**Town of Nags Head Planning Board
Nags Head Municipal Complex Board Room
Tuesday, June 18, 2024; 9:00 a.m.**

- 1. Consideration Of A Site Plan Amendment
for the construction of an 87-unit Hotel (Inn at Whalebone), including a request to eliminate or modify the condition of the October 4, 2023, Board of Commissioners approval that the existing Lakeside Street roadway be expanded to accommodate three (3) lanes of traffic, and the three (3) lanes should extend to the most westward entrance of the hotel off Lakeside Street. The property is zoned SPD-C Village Hoel and is located within the Hotel Overlay District, located at 6632 Pheasant Avenue/Lakeside Drive, Nags Head.

Subject: Site Plan Amendment for Inn at Whalebone, 87-unit Hotel located at 6632 W. Pheasant Avenue (W. Lakeside Street).

06001.00 - THE INN AT WHALEBONE, LLC - TRAFFIC IMPROVEMENTS FOR W. LAKESIDE ST.

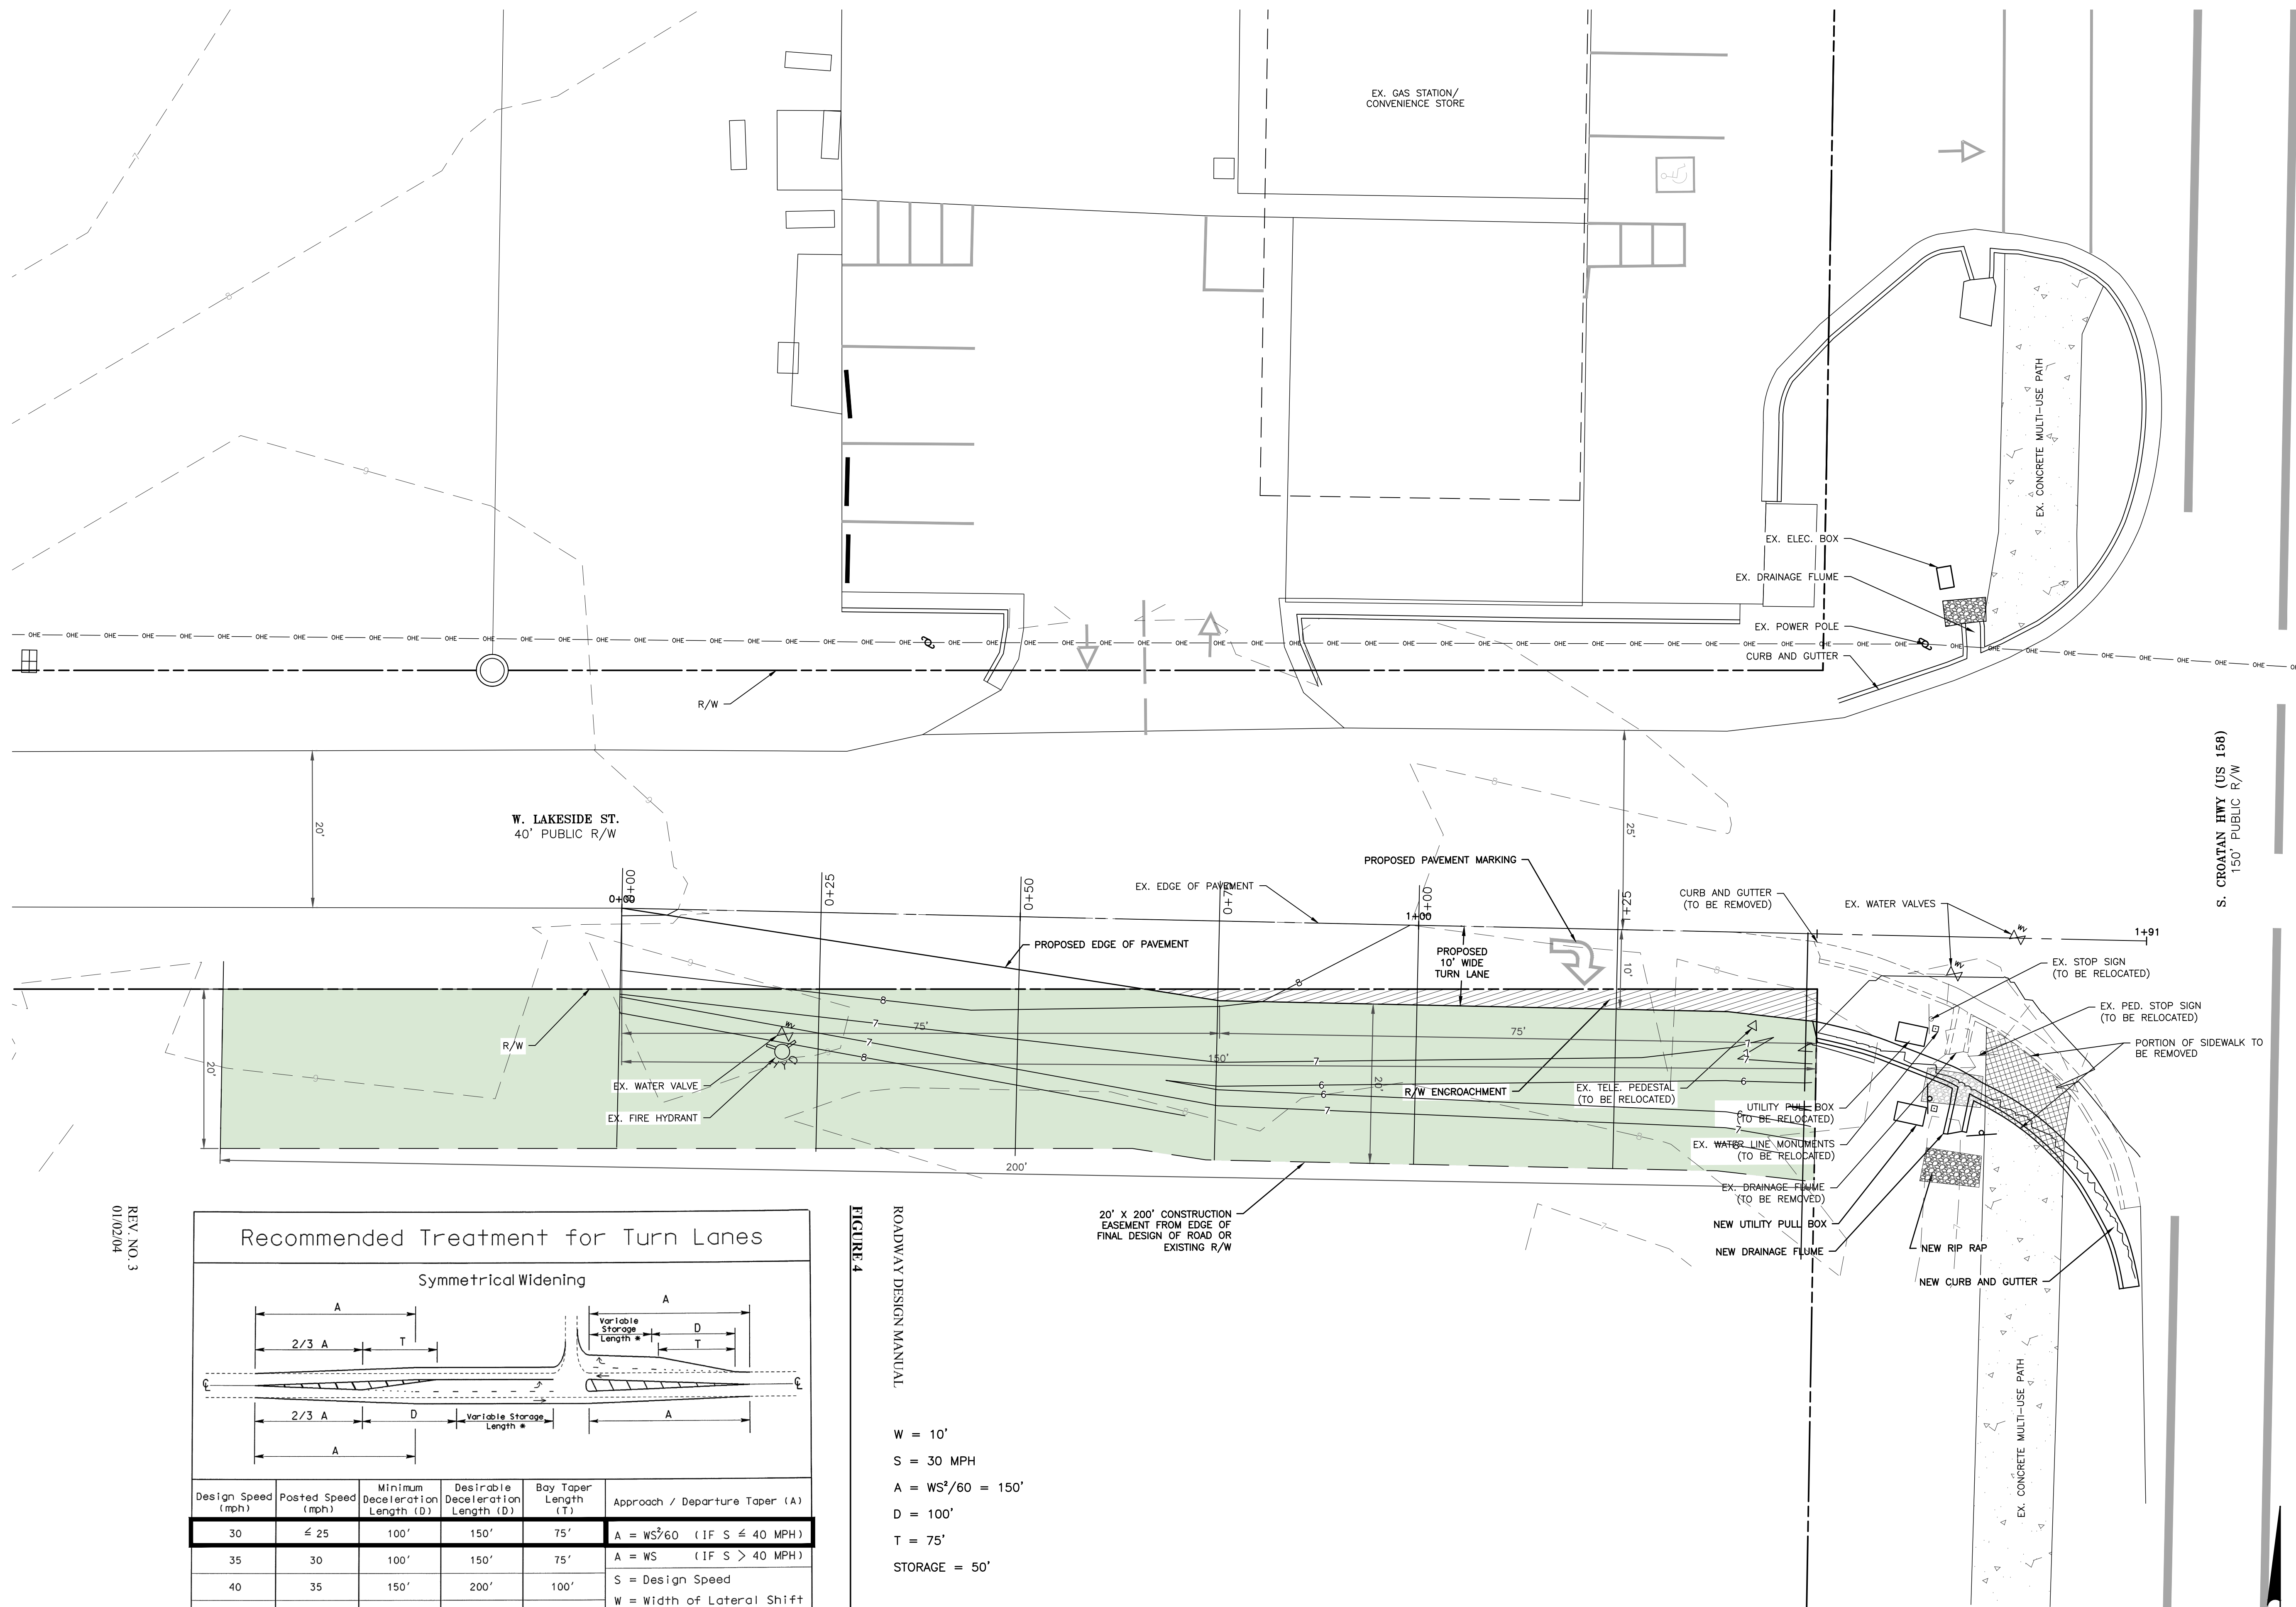
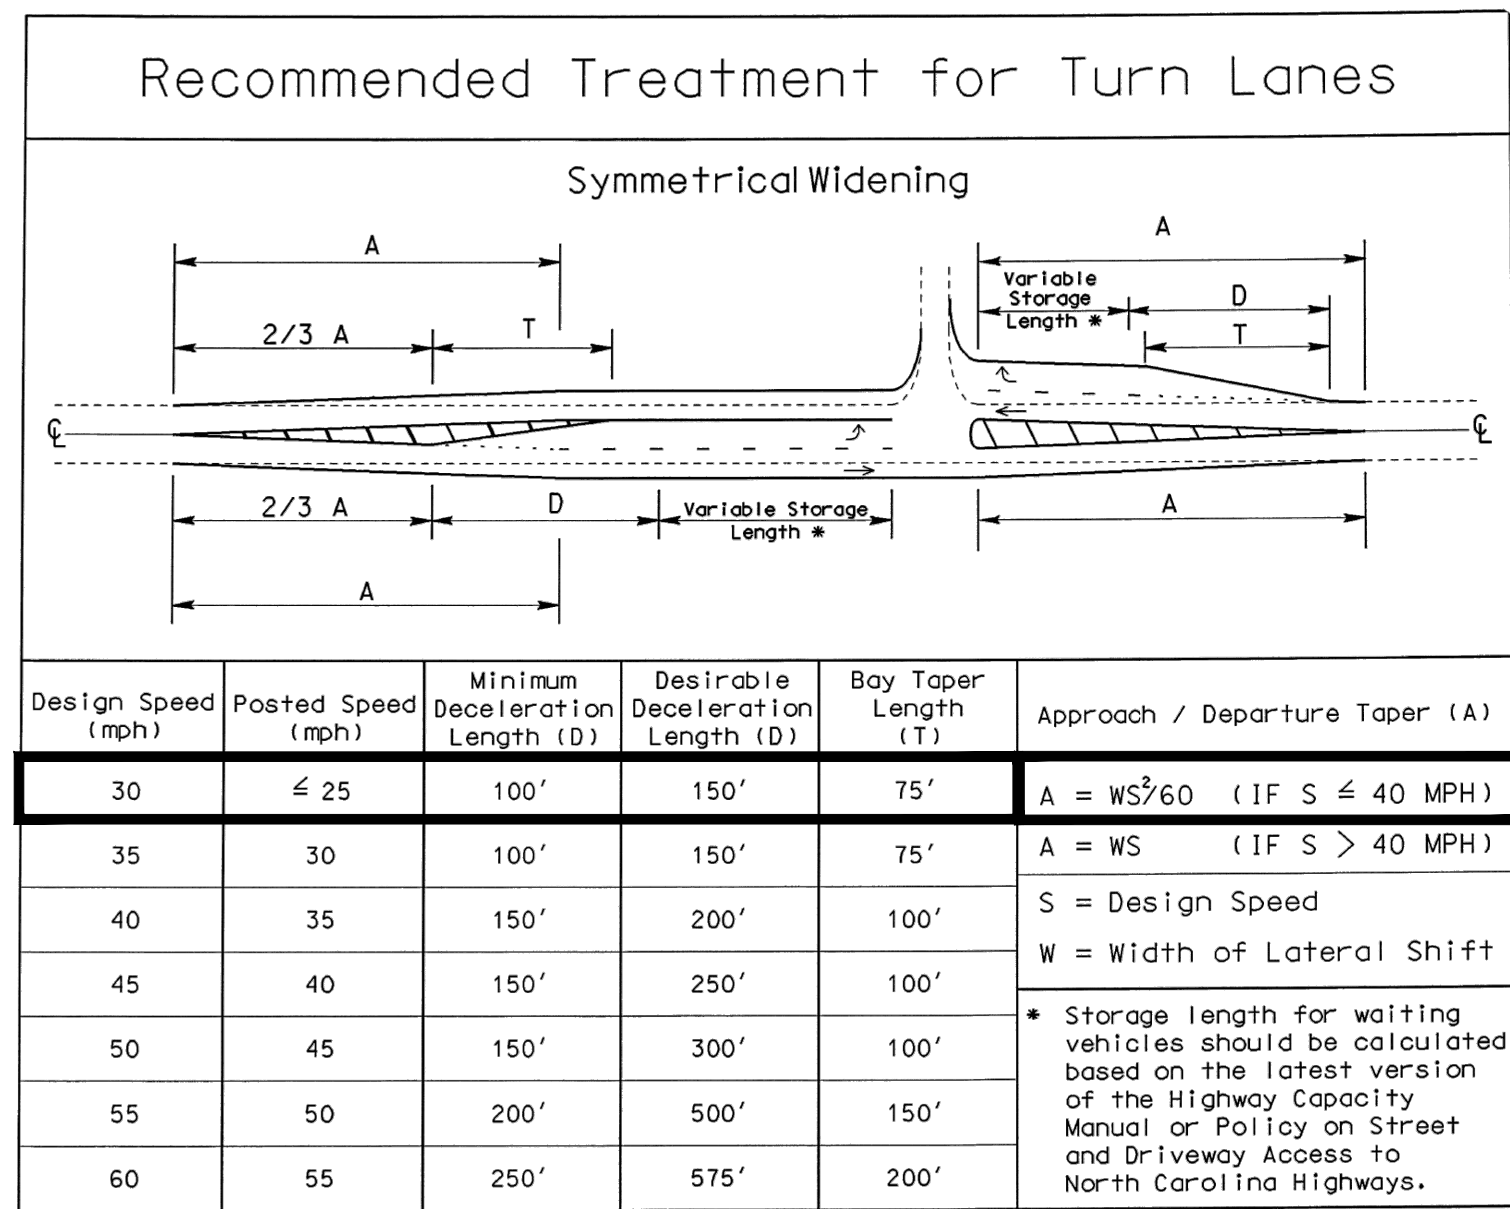
“Lakeside Street Turn Lane Exhibit- A condition was placed on the previous site plan approval to widen the Lakeside St roadway extending from S. Croatan Hwy. to the westernmost boundary of the subject property. With the existing Lakeside St. right-of-way width at 40’ there are some impacts associated with a roadway widening of this length. These impacts include runoff onto adjoining properties and potential conflicts with above ground utilities. However, there is still an opportunity to provide roadway widening to meet the intent of the previous Board of Commissioners conditioned approval.

The applicant has submitted an exhibit which shows a reduced widening plan from the eastern property boundary. This concept indicates an encroachment onto the adjoining undeveloped property to the south. Attached is an exhibit mark-up which describes a potential alternative roadway widening approach which may not result in improvements extending onto private property. The recommendation is for the applicant to modify the traffic improvements for Lakeside St. to reflect the approach as identified in the attached plan mark-up. This approval would be conditioned on the applicant acquiring detailed survey information for the development of a roadway widening and construction plan in accordance with Chapter 36-4 of the Town Code of Ordinances. It should be noted that a temporary construction easement may be required from the owner of the undeveloped property to the south for the purposes of construction in addition to a right-of-way encroachment through NCDOT.”

Regarding the applicant's request to remove or modify the condition to widen Lakeside Street, this condition was included in the October 4, 2023, Board of Commissioners (BOC) approval to address traffic concerns raised by citizens and Board members. While fully meeting this condition could impact runoff onto adjacent properties and conflict with above-ground utilities, there is an opportunity to widen a portion of the roadway. This approach would fulfill the intent of the Board of Commissioners' conditioned approval without encroaching on adjoining properties. Staff recommends that the Planning Board recommend modifying the previous BOC approval to reflect the alternative roadway design proposed by the Town Engineer.

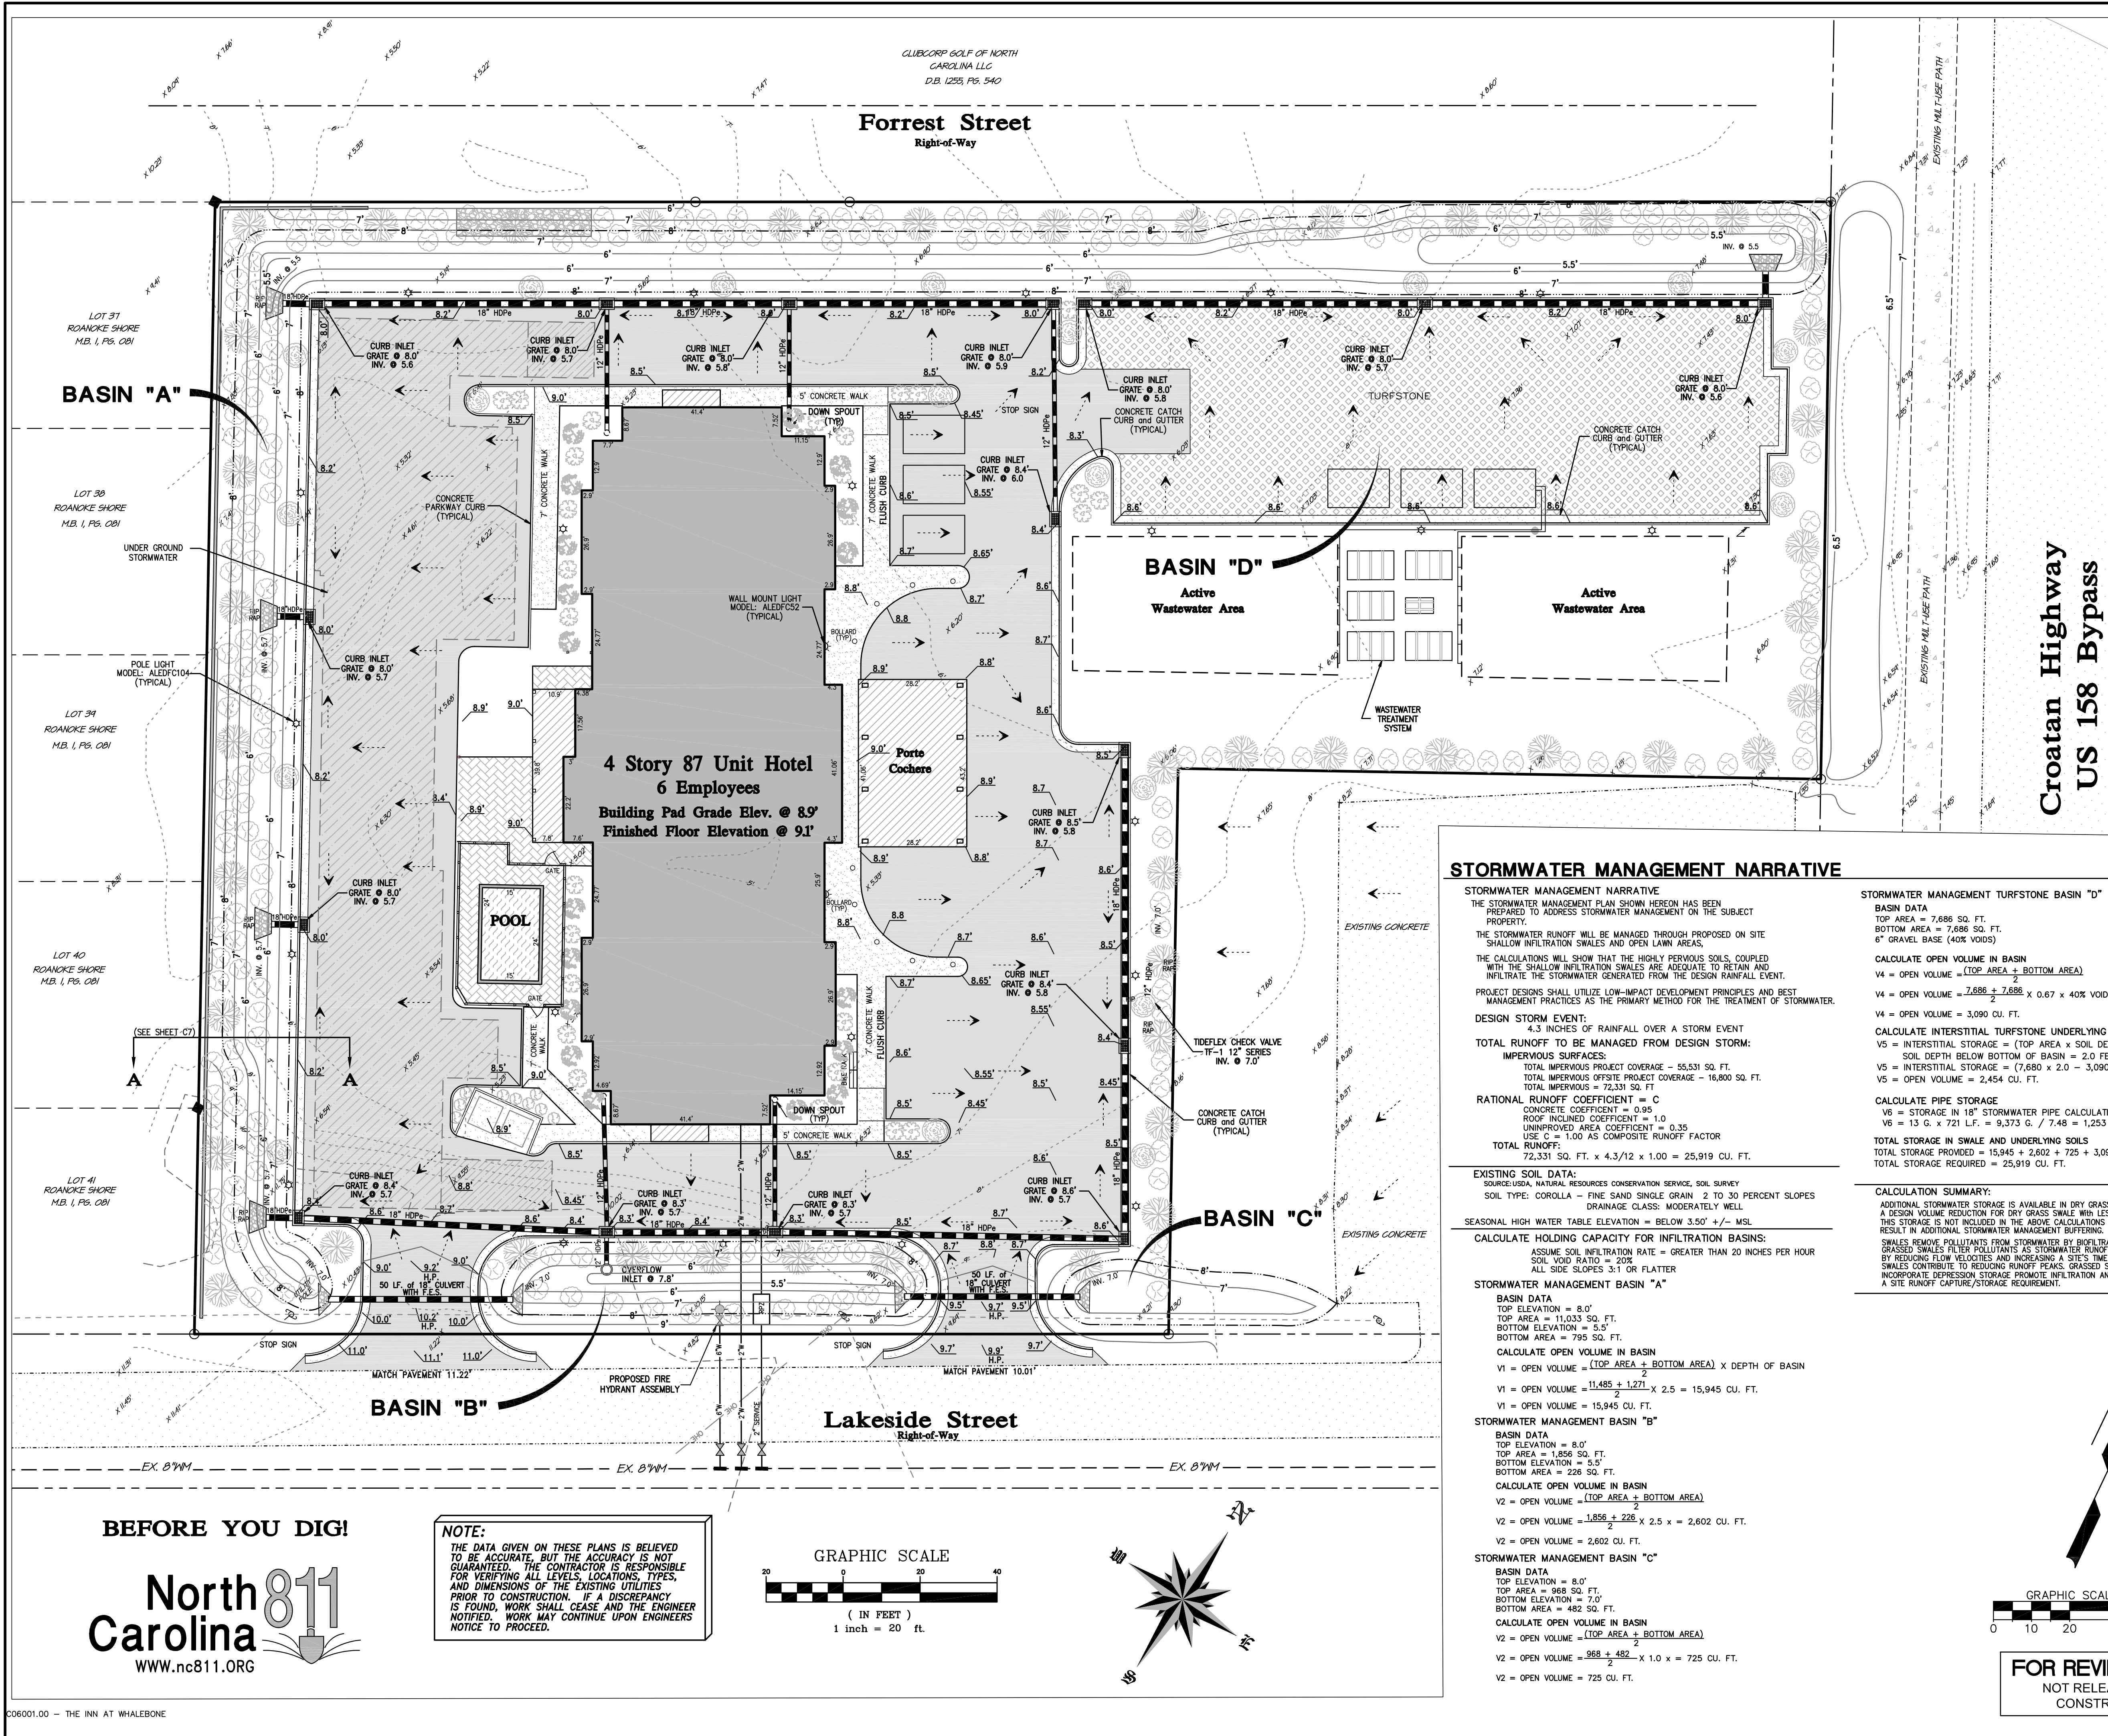
Town Engineer David Ryan has reviewed the revised plans and notes that the stormwater narrative on Sheet C-103 indicates a Seasonal High Water Table Elevation of 3.50' MSL. The typical infiltration basin detail indicates a SHWL of 4.8'. This discrepancy should be clarified. The stormwater management design information submitted appears to be in substantial compliance with the Town of Nags Head Unified Development Ordinance.
